SUBJECT: DRESDEN NUCLEAR POWER STATION, UNITS 2 AND 3  
NRC SAFETY SYSTEM DESIGN AND PERFORMANCE CAPABILITY  
INSPECTION REPORT 05000237/2005009(DRS); 05000249/2005009(DRS)

Report No: 05000237/2005009(DRS); 05000249/2005009(DRS)

Facility: Dresden Nuclear Power Station, Units 2 and 3

IR 05000237/2005009(DRS); 05000249/2005009(DRS); 07/25/2005 - 08/12/2005; Dresden Nuclear Power Station, Units 2 and 3; Safety System Design and Performance Capability.

Predicted Loads Exceeding Surveillance Requirements

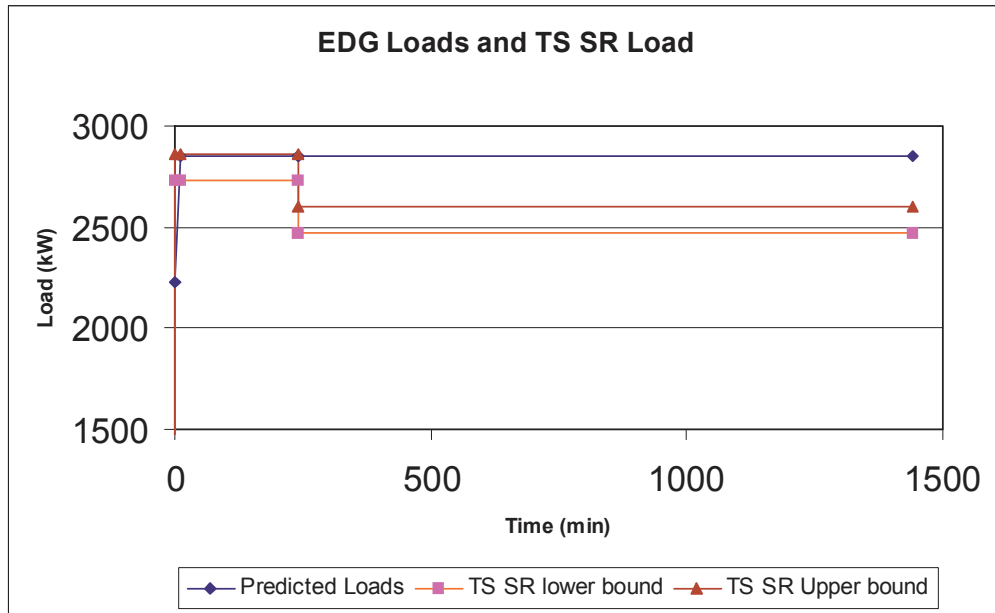
The original concern of the URI regarding the lack of a surveillance requirement which enveloped the design basis loads remains open. The table above and chart below depict where the Dresden EDGs would operate within the 10 percent overload rating beginning at 10 minutes after a design basis event and for an extended period of time after manual loads were added onto the EDG. However, the current TS surveillance requirements, and licensee testing practices, only demonstrated the ability of the EDG to carry a load near this level for 2 hours.

This created a situation in which the licensee’s surveillance requirements did not envelope the design basis accident loads. The current 24-hour surveillance test procedure specified 2730 to 2860 kW for 2 hours. This was potentially less than the design load requirement of 2851 kW for an extended period. The licensee maintained that there was no commitment on their part to envelope the design basis loads during this surveillance test. However, the inspectors questioned whether this was an adequate demonstration of the EDGs capability to carry design basis loads.

Since these two issues were inter-related and could not be resolved with the licensee, the two issues will be combined into URI 50-237/02-06-02; 50-249/02-06-02. This concern will remain open pending resolution of the issues through a Task Interface Agreement (TIA) with the Office of Nuclear Reactor Regulation. In general, the resolution of these issues need to address whether the TS surveillance provides reasonable assurance of the EDGs capability to carry design basis loads and whether operating the EDG at the reactive load for only 10 minutes of the 24-hour run meets the supporting regulatory analysis and intent of the surveillance requirement.
